EXAMPLE #1

For projects less than one acre and no new connections to the City/County storm sewers

PRELIMINARY SITE PLAN REVIEW

sheet title:
Storm Water
Management Plan
Summary Sheet

PROJECT MANAGEMENT - PUBLIC SERVICES - CITY OF ANN ARBOR	
UNIVERSITY OF MICHIGAN WILLIAM L. CLEMENTS LIBRARY INFRASTRUCTURE IMPROVEMENTS AND ADDITION UM PROJECT NUMBER: P00001692 RIGHT OF WAY GRADING PLAN	
SCALE HORIZ. 1"=20' VERT. 1"=2'	0 INCH 1
DRAWING NO.	CG1.1
SHEET NO.	OF

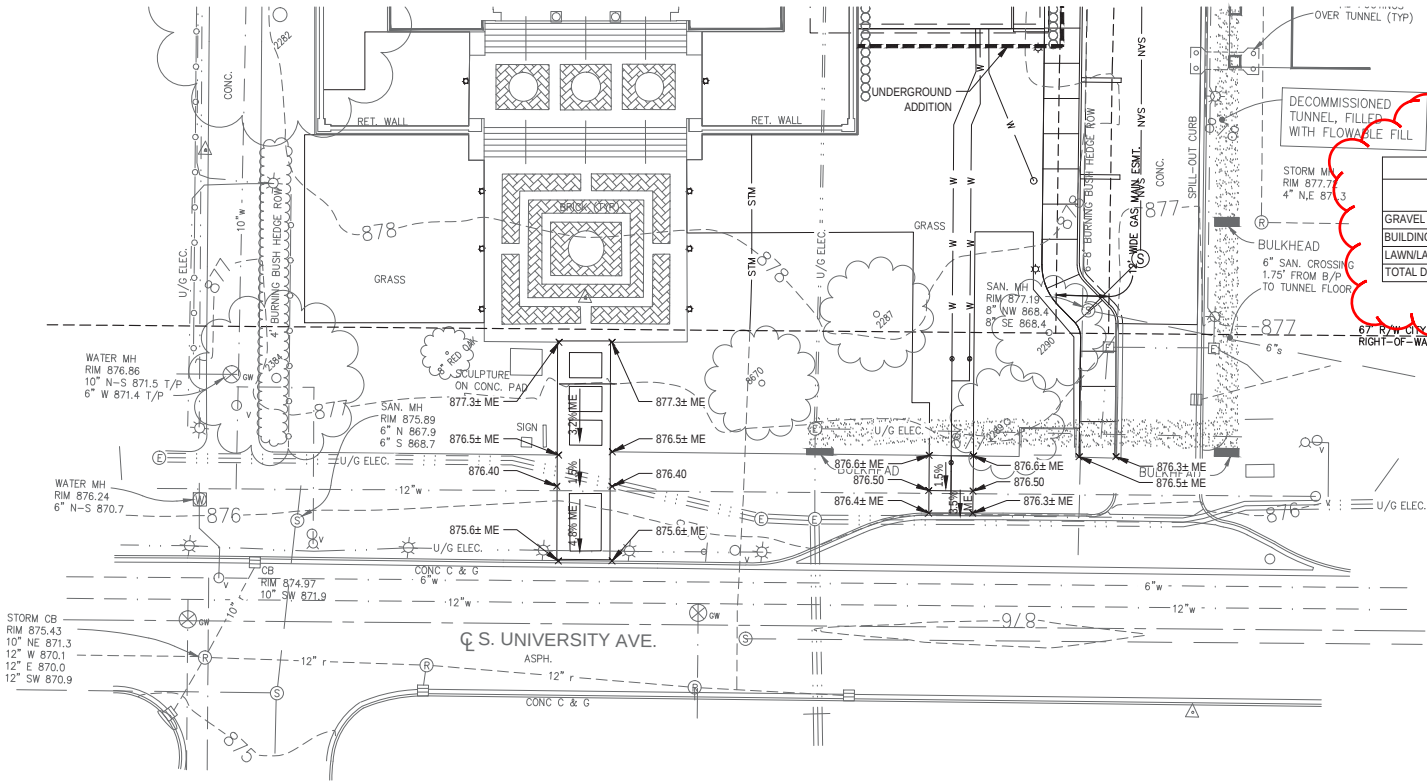
Show chart of with change in impervious -see attached example chart. Increase in impervious must be reviewed/approved by U-M Campus Planning and project team may be directed to design additional storm water management BMPs.

Provide a list of elective storm water BMP's to be installed and quantify benefits, if feasible.

Include the language: "Construction and operation of the storm water (infiltration/detention pond) or (BMP's on the plans) is/are in compliance with the requirements of State and Federal water pollution control laws."

Replace chart with format matching example chart below

C104C

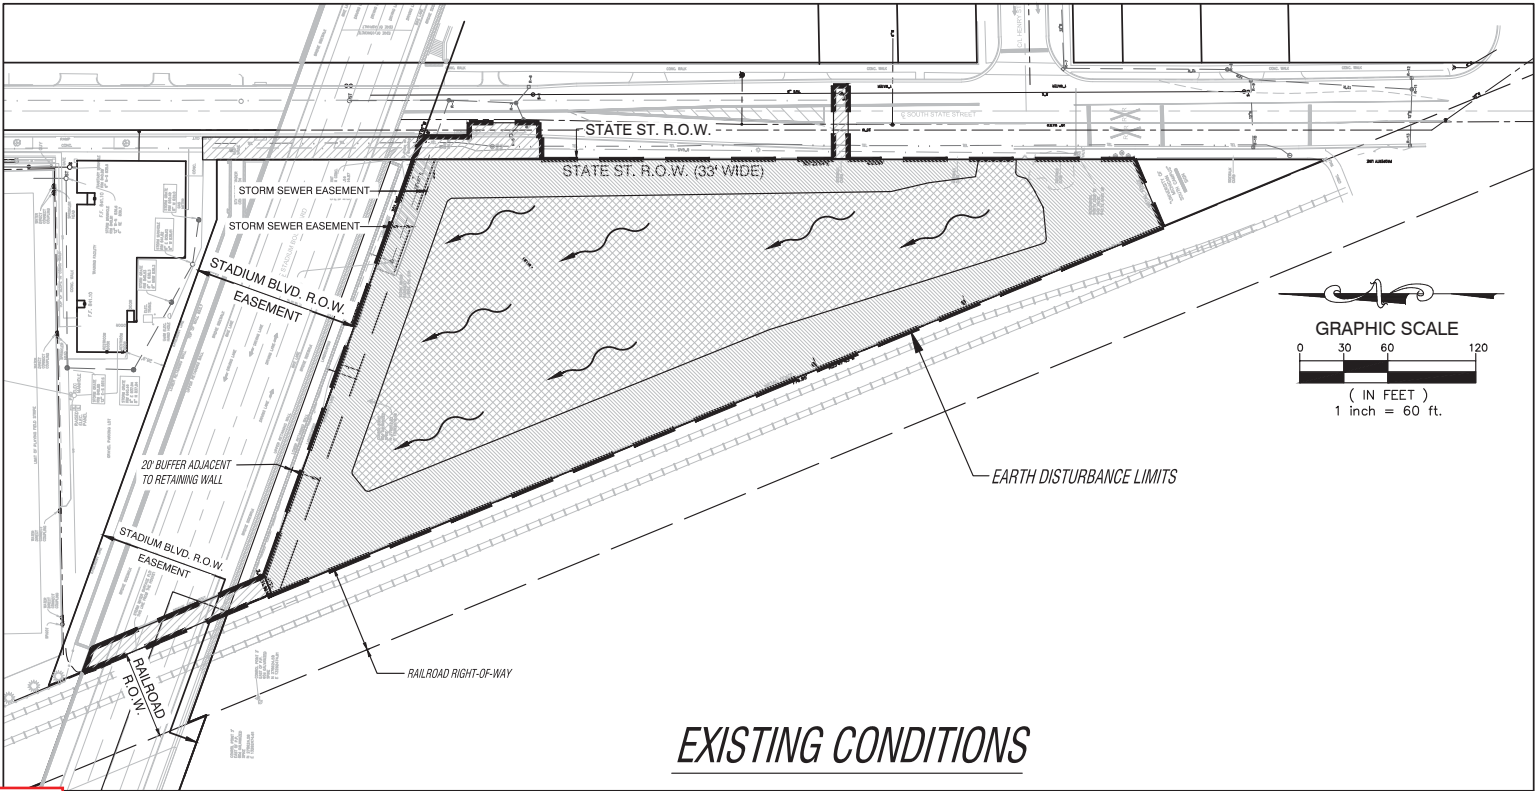
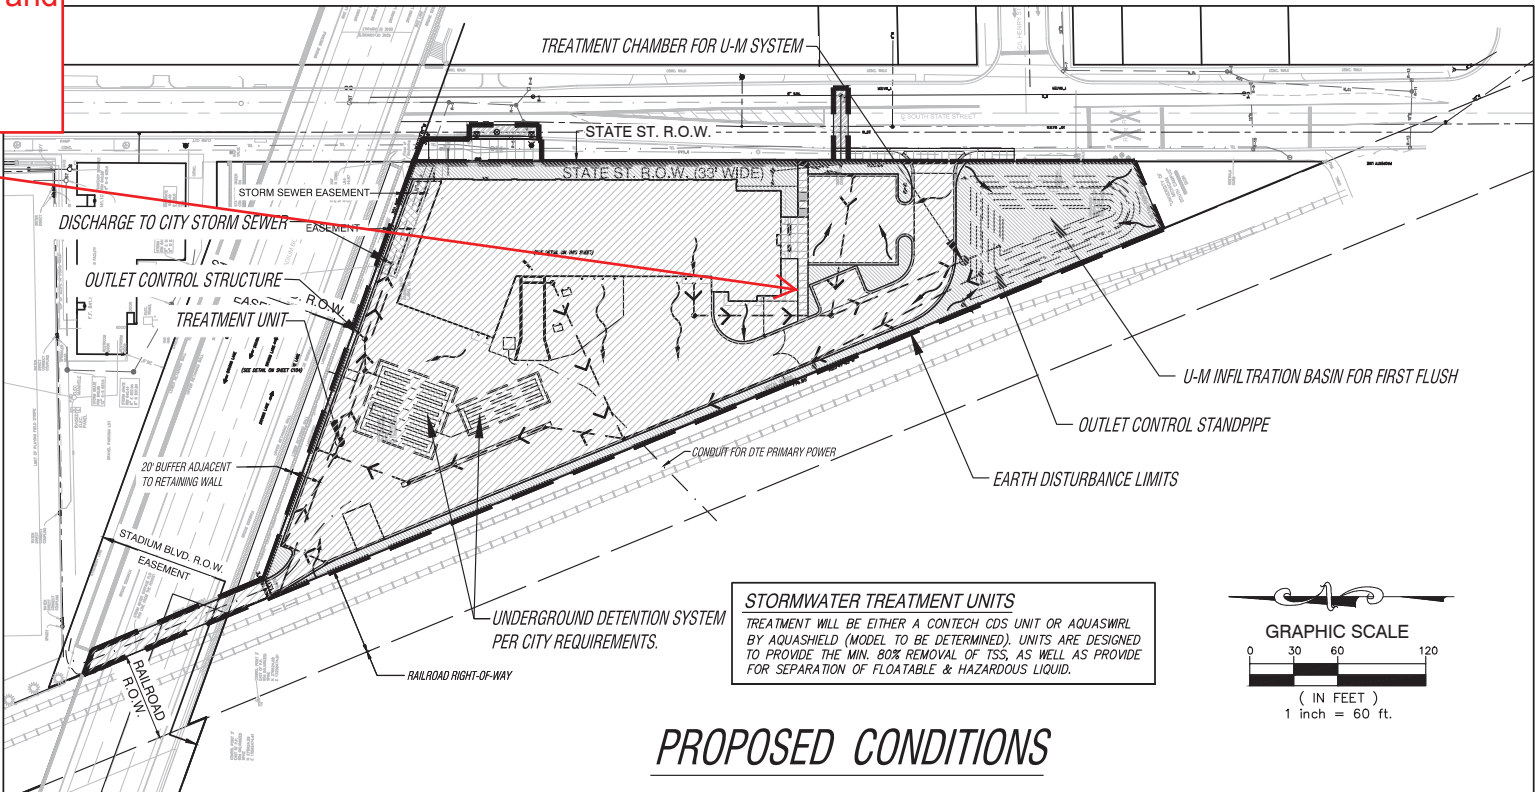
- Storm water sheet.
- Show drainage patterns of proposed and existing conditions with different hatching based on imperviousness. (See Campus Planning level of detail provided on U-M property)
- Provide narrative summarizing storm water as noted below.

Storm water narrative

C104AC

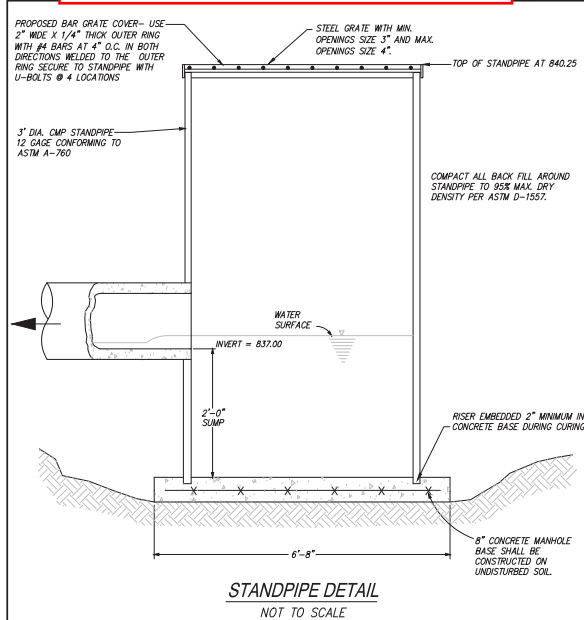
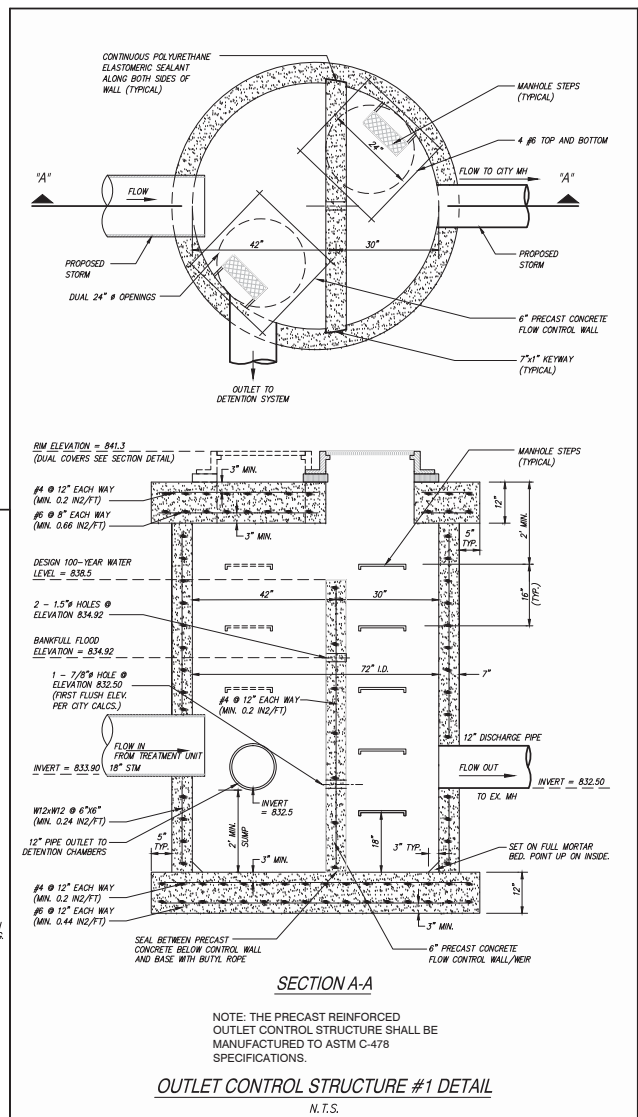
Provide sheet with storm water management plan.

Include details for storm water management structures.
